LAND USE BOARD APPLICATION

**Re: Completeness Review No. 1
Minor Site Plan w/ Use Variance
Applicant: Mark Landgrebe
Block 58, Lot 7.01
44 Miller Street
Borough of Highlands, Monmouth County, New Jersey
REG File No.: HLPB25-10**

MINOR SITE PLAN
W/ 'D' VARIANCE
44 MILLER STREET
LOT 7.01 BLOCK 58
BOROUGH OF HIGHLANDS
COUNTY OF MONMOUTH NEW JERSEY

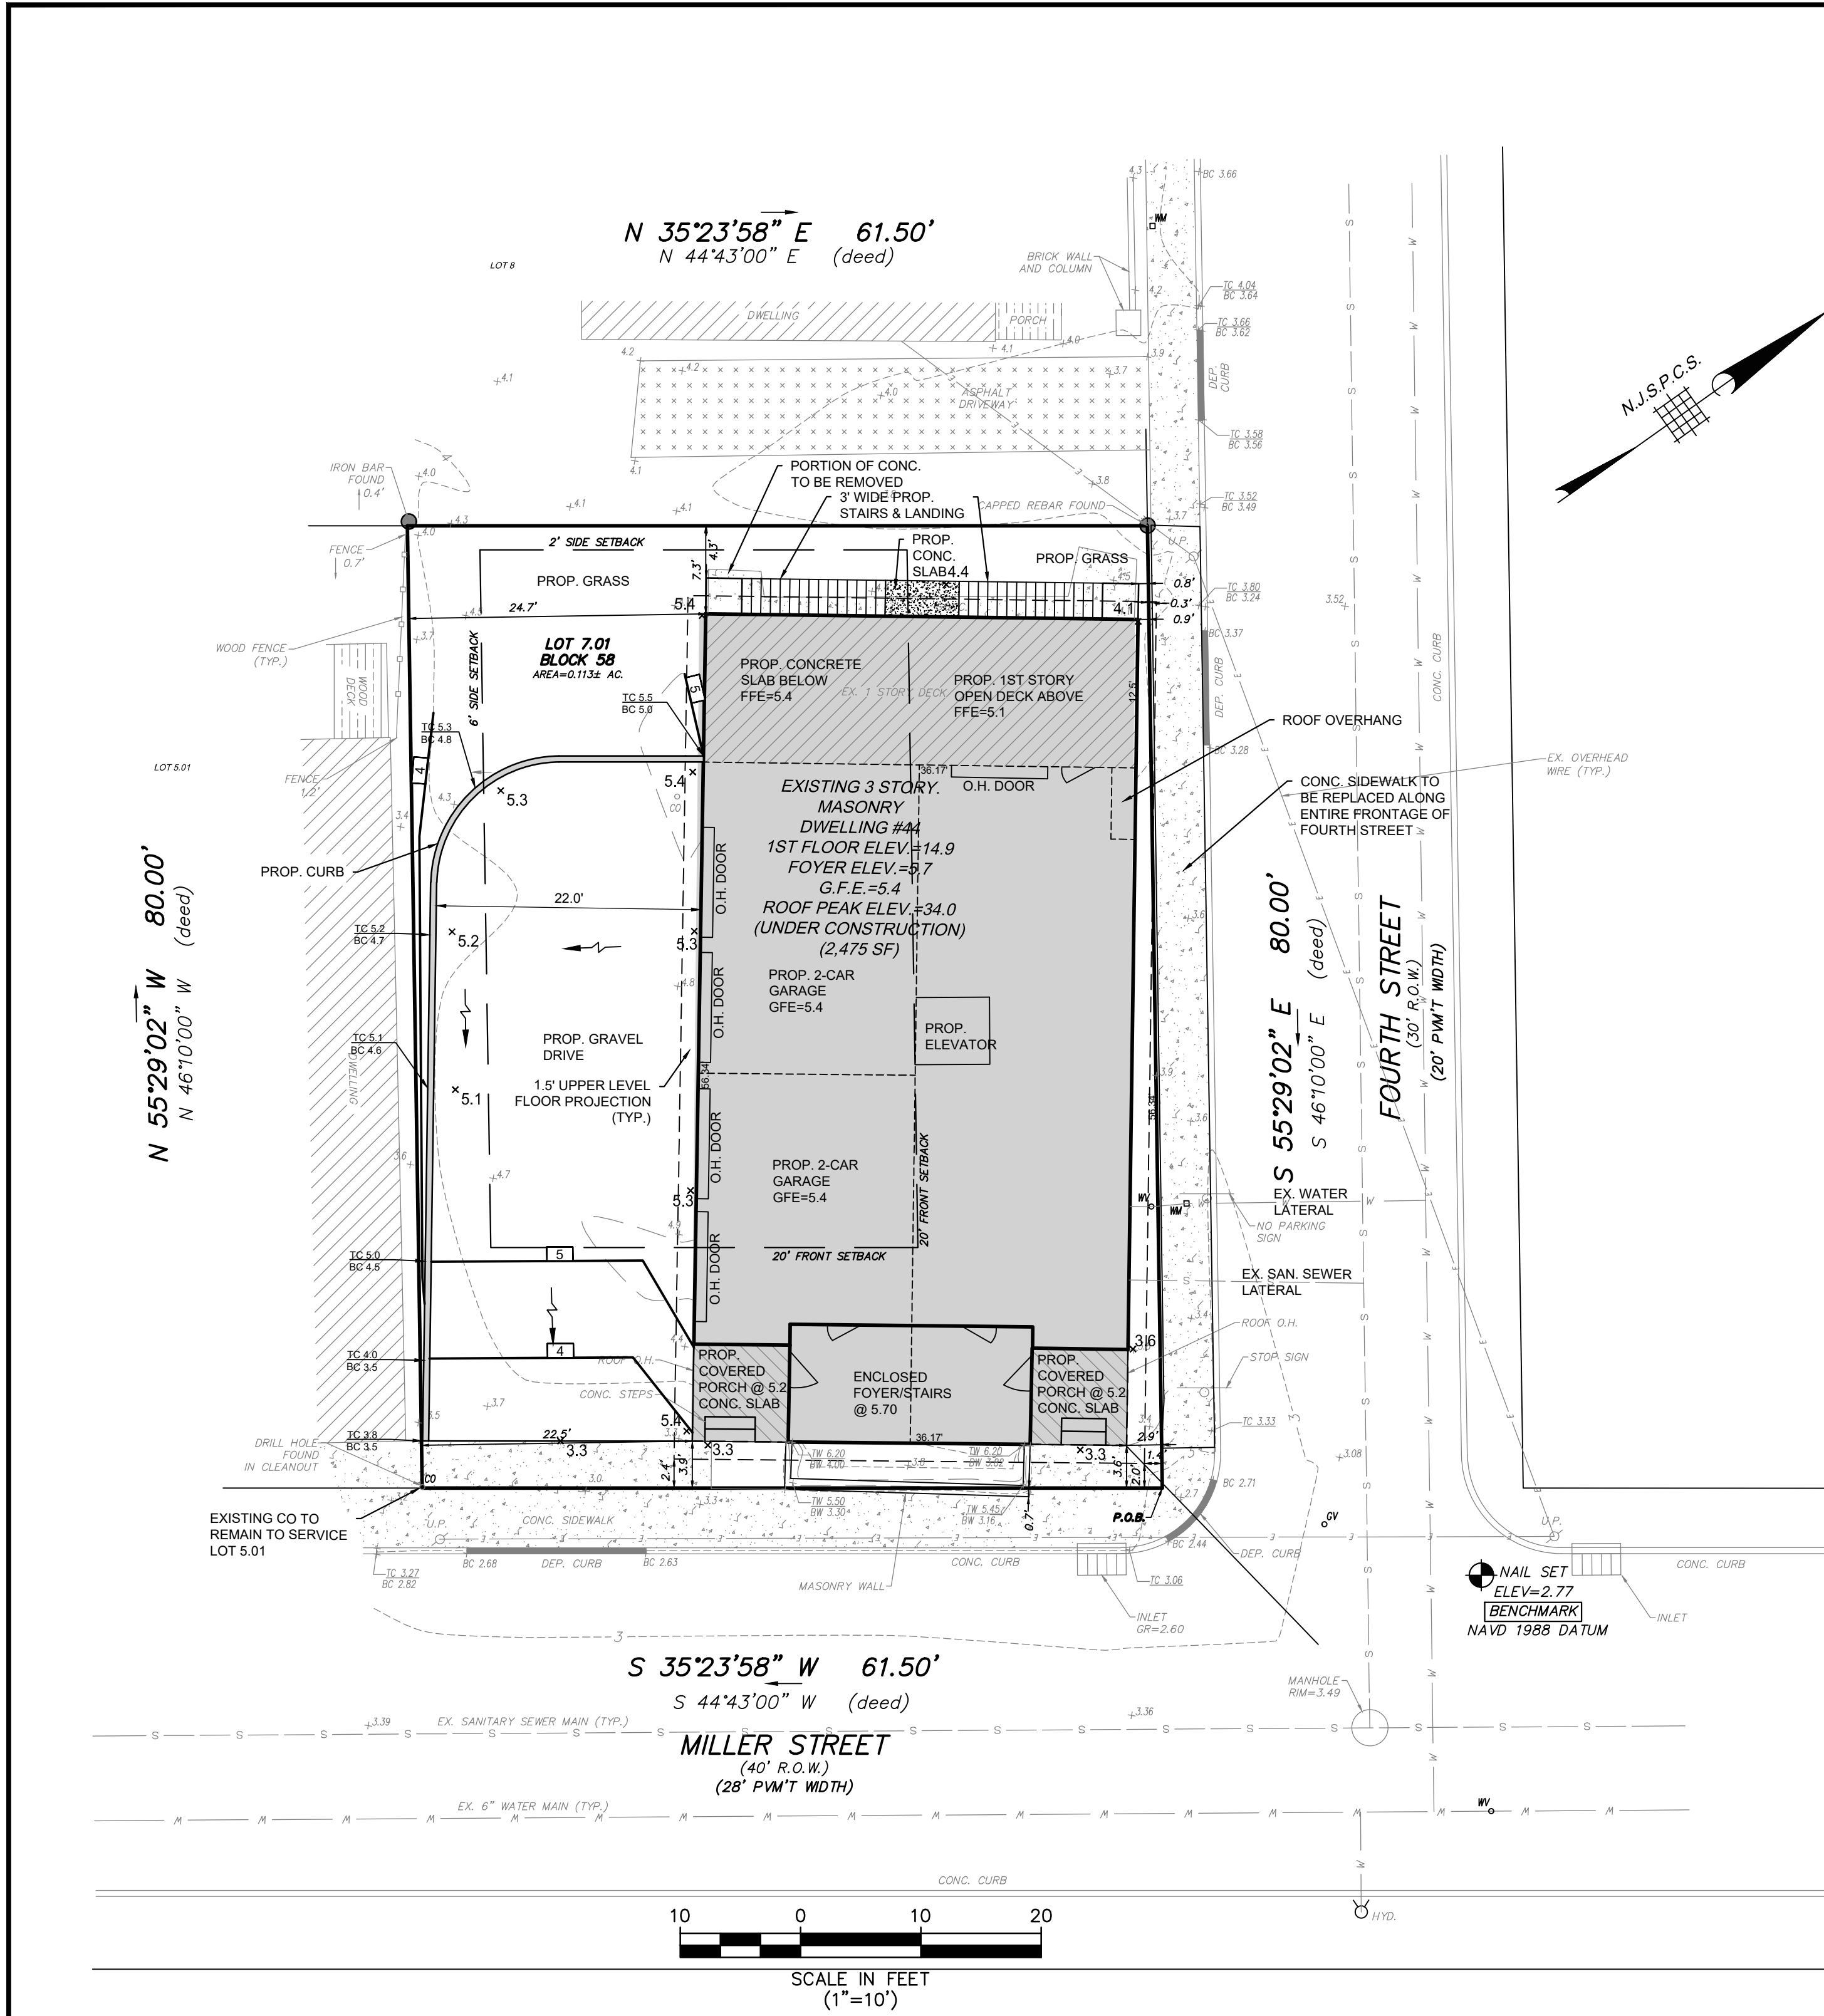
Please provide a deck setback category on the zoning table.

Provide the 3 ft deck setback line along the front and side property line.

Provide the proposed front and side yard setbacks (building) for Fourth Street on the plan. The deck setbacks are shown.

Provide building dimensions on the proposed dwelling.

9. Please provide the dwelling and driveway on Lot 8.
10. Please provide the front and side overhangs with offsets to Miller Street and Fourth Street rights-of-ways on the Site Plan.

11. Dimension the encroachments of the masonry planter to the Miller Street rights-of-way line and note any encroachments.
12. Please provide elevations for the front and rear corners of the proposed building.
13. Please indicate the BFE and FF. The roof peak elevation shown on the site plan is not consistent with the architectural plans.
14. Please clarify if the boundary of the gravel driveway is a curb or a wall. TW and BW elevations are shown, and the boundary is noted as proposed curb.

19. Provide a concrete pad for the landing of both stairways to the elevated deck. Provide grades.
20. This application proposes a gravel driveway.
21. Indicate the grass and any landscaped areas on the plan.

23. Provide the location of existing water, sewer and gas service lines. Indicate if any changes are proposed. Will any service lines be replaced or relocated?

24. Confirm if the cleanout which is located at the common corner of Lot 7.01 and Lot 5.01 serves Lot 7.01 and indicate on the plan. Indicate if it is to remain in service or be abandoned.

The sidewalk along Fourth Street is in poor condition and we recommend full replacement.
26. According to §21-123.2 mechanical, plumbing and electrical systems should be above Local Design Flood Elevation (LDLE). Please provide a note.

Response: The zoning schedule has been updated accordingly.

Response: The zoning schedule has been updated accordingly.

Response: The zoning schedule has been updated accordingly.

Response: The building dimensions have been added as requested.

Response: The existing driveway and dwelling for adjacent Lot 8 have been added to the Minor Site plan set.

Response: The roof overhang has been added to the building on Fourth Street, adjacent to the 1st. story open deck. A 1.5-foot floor projection line and front yard setback distances have been added to the Minor Site Plan set.

Response: The masonry planters offset into the R.O.W. of Miller Street has been added as requested.

Response: Elevations have been provided at the building corners.

Response: The architectural plans proposed finish floor elevations must be revised to reflect the existing conditions/topographic information. The Minor Site Plan set provided the Finish floor elevations for garage, covered porch, foyer and first floor elevations along with a building height detail with the design flood elevation.

Response: The gravel driveway is bounded by concrete curb.

Response: A six foot long concrete pad has been provided at the bottom of the stairs where the stairs meet grade.

Response: Grass is proposed in the rear area of the site.

Response: Existing utilizes located within the R.O.W. of Fourth Street and Miller street has been added to the plan. Clean outs and water valves are also shown. There are to be no proposed water and sanitary sewer connections proposed. The existing connections shall be reused.

Response: It appears that the clean out is not associated with Lot 7.01.

Response: The sidewalk along Fourth Street has been called out for replacement in kind.

Response: A note stating same has been added to the Minor Site Plan set.
